Land south of Station Road, Cowfold, RH13 8QZ

Adoptable Drainage Details Sheet 2

15478-TUL-XX-XX-DR-C-65003

Headwall MHS15 Detail - Discharge into the Ditch

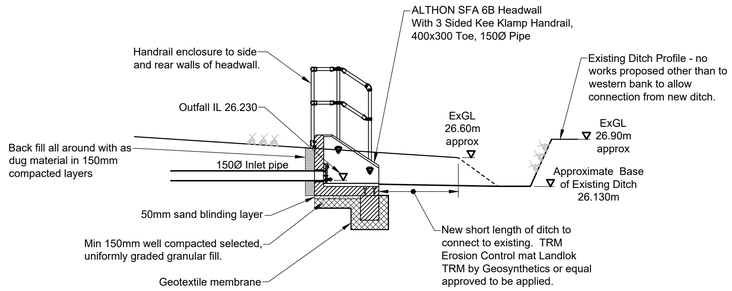
Rev	Date	Description	By	Ckd
P04	24.07.26	Detention basin attenuation volume increased from 1200 to 1380m³ to allow for Cv change from 0.9 to 1.0. Gabion baskets extended slightly in length to suit the above and levels adjusted to suit low flow channel. Headwall MHS15 position amended to match plan.	PAJT	.
P03	07.01.26	General notes updated.	IU	PAJT
P02	11.11.25	Gabion baskets added to basin layout. Concrete backwork replaced with concrete headwalls.	IU	PAJT
P01	12.09.25	Previously Private Drainage Details Sheet 2 Rev P02 (which is now withdrawn). All headwalls shown as concrete bagwork. Dry Detention Basin section updated to show low flow channel.	IU	PAJT
